CMB Meeting Minutes #149

SUBJECT: Configuration Management Board Meeting # 149 – Rev. No. 0

Contract 1300 - PCC No. 6: STS AT&T Relocation

Powell Street
Vault 1087

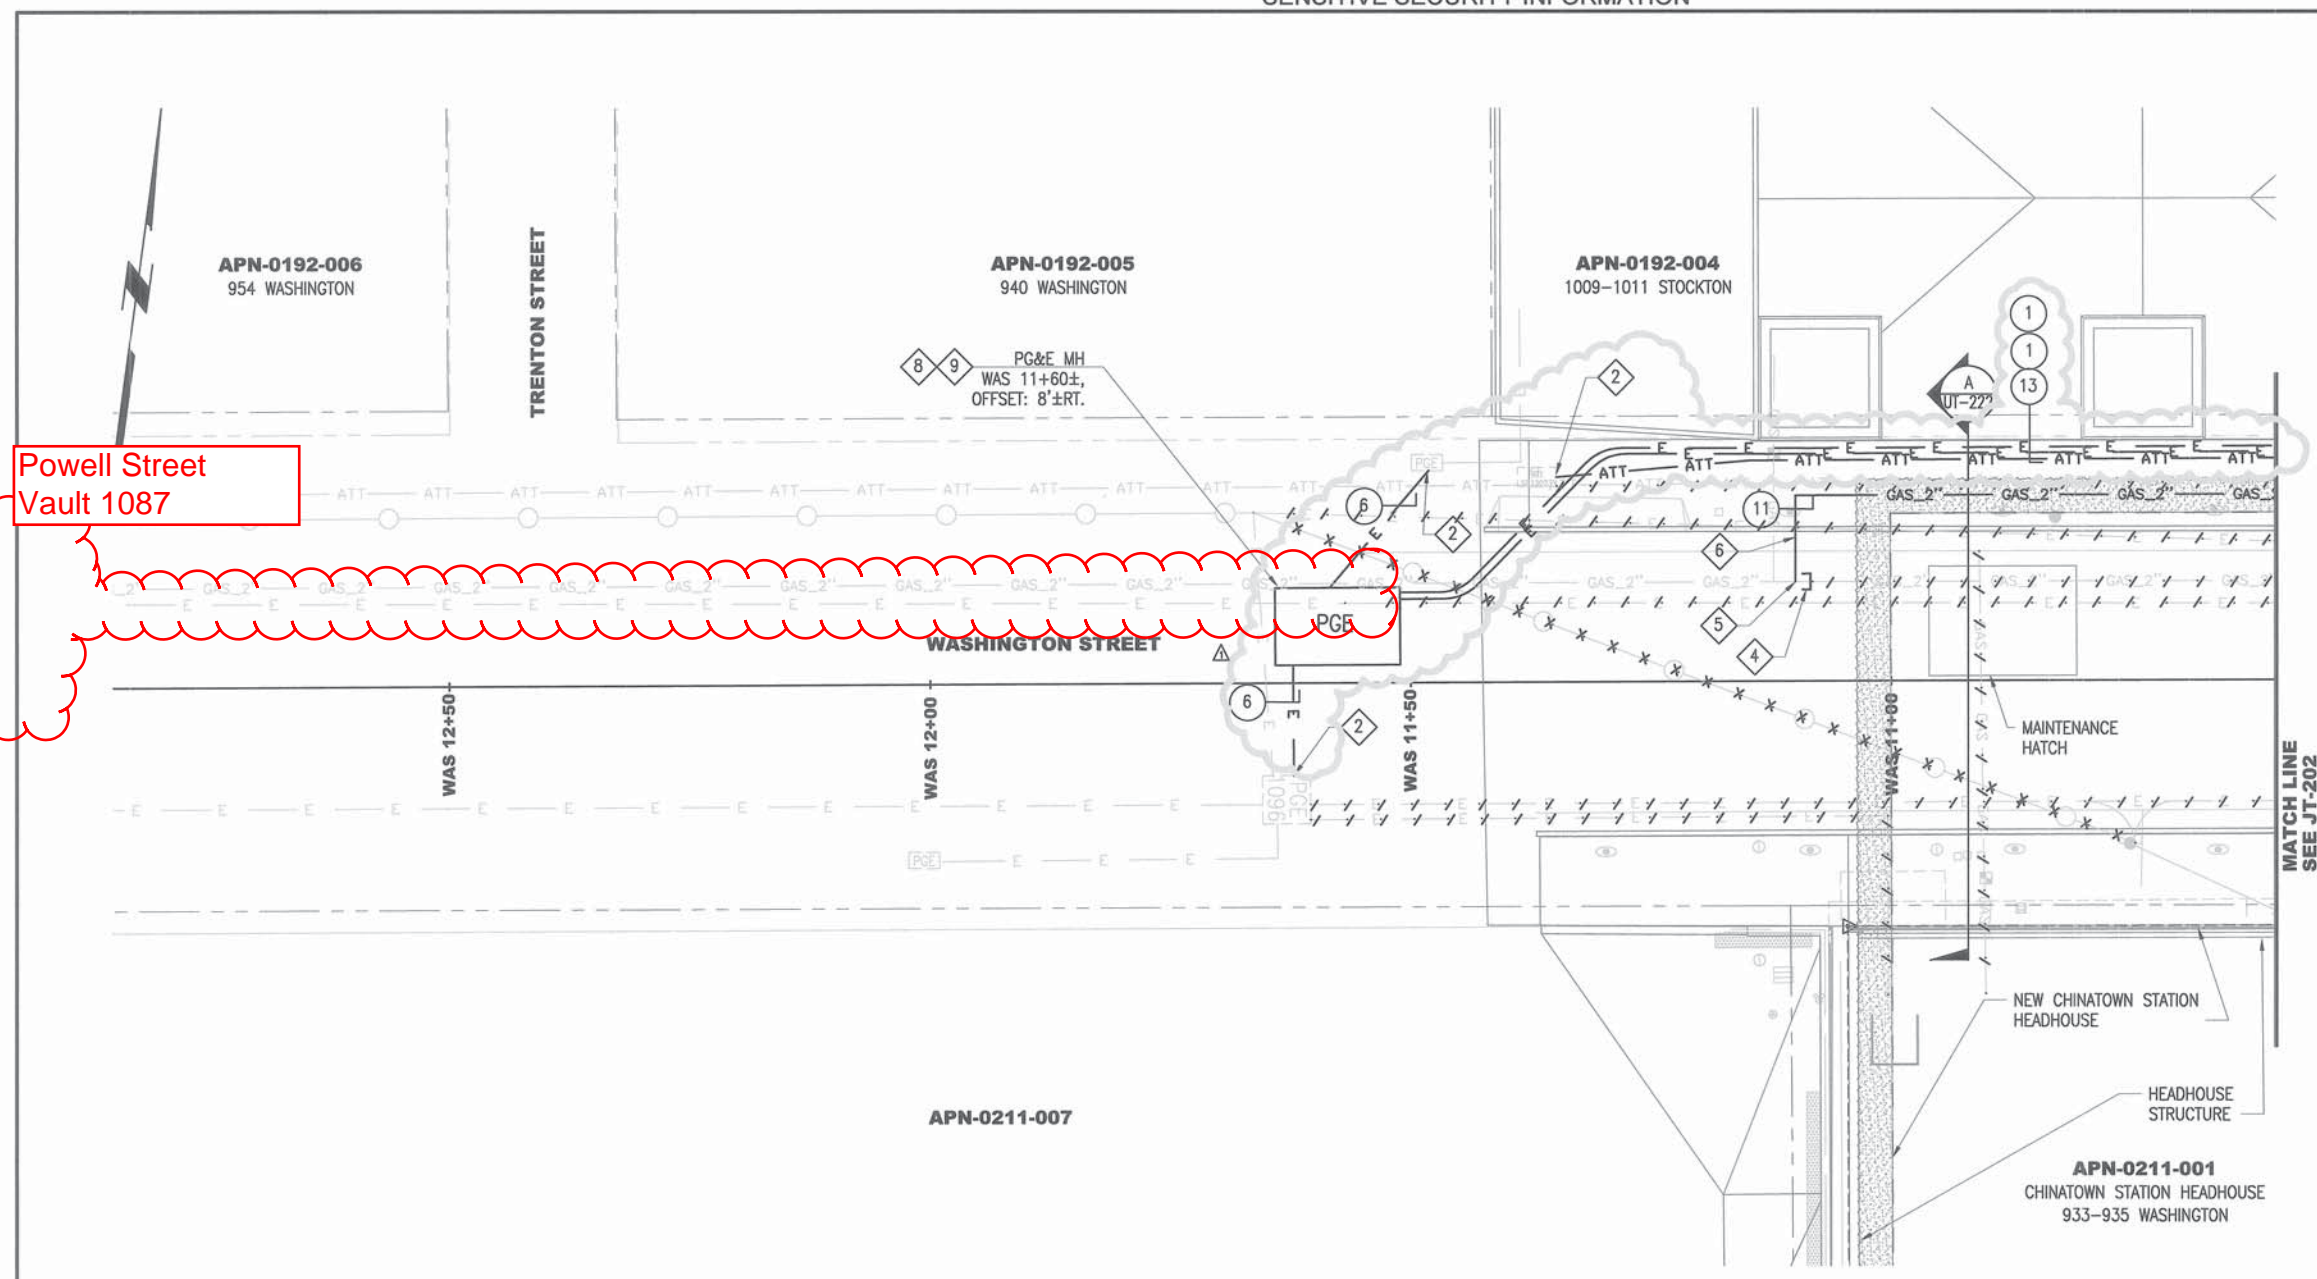
Description of PCC: Traffic Control for PG&E work on Stockton in areas not shown on the contract.	
Summary of Changes:	
<ul style="list-style-type: none"> • Provide traffic control for PG&E work item 30 (to access vaults 1850P and 726) so PG&E can install and terminate a new cable allowing one feed from the power pole to be removed. • Provide traffic control for PG&E work at on the east side of the intersection of Powell St. and Washington St. Item 20 (to access vault 1087). This is to remove existing conductors between vaults 1087 and 729 which allows TPC to install a "NEW" vault in the middle of this conduit duct bank. Our drawings only show cable removal from the "new" vault to vault 729. • Provide traffic control for PG&E work to allow new conductors to be pulled Item 22 between existing vault 1087 and the new vault. These new conductors will then provide service to the Gordon J. Lau School, allowing the second feed from the existing power pole to be removed.

Description of PCC: Traffic Control for PG&E work on Stockton in areas not shown on the contract.
Reason/Need for PCC: In order to remove the PG&E power pole that is located on the CTS headhouse site, PG&E needs to maintain service to several customers. PGE has determined that there are several electrical cables that need to be pulled in and terminated in order to provide these services. Additionally, one cable run needs to be cut and removed to allow installation of the "New" vault. These locations are not shown on our drawings.
Location/Station: PG&E work at item 30 (to access vaults 1850P and 726), approximately station CTL 104+75 left. (Approximately three nights) PG&E work item 20 to access vault 1087 (Powell and Washington intersection)to remove existing conductors (Approximately one night) PG&E work item 22 to access vault 1087 (Powell and Washington intersection)to install new service cable to provide power to the Gordon J. Lau school (Approximately two nights)

Configuration Control Analysis: (Design Control)
Recommended Action: Provide traffic control so PG&E can perform the necessary work.
Estimate:
Spec. Ref.: 33 41 10 Joint Trench Infrastructure
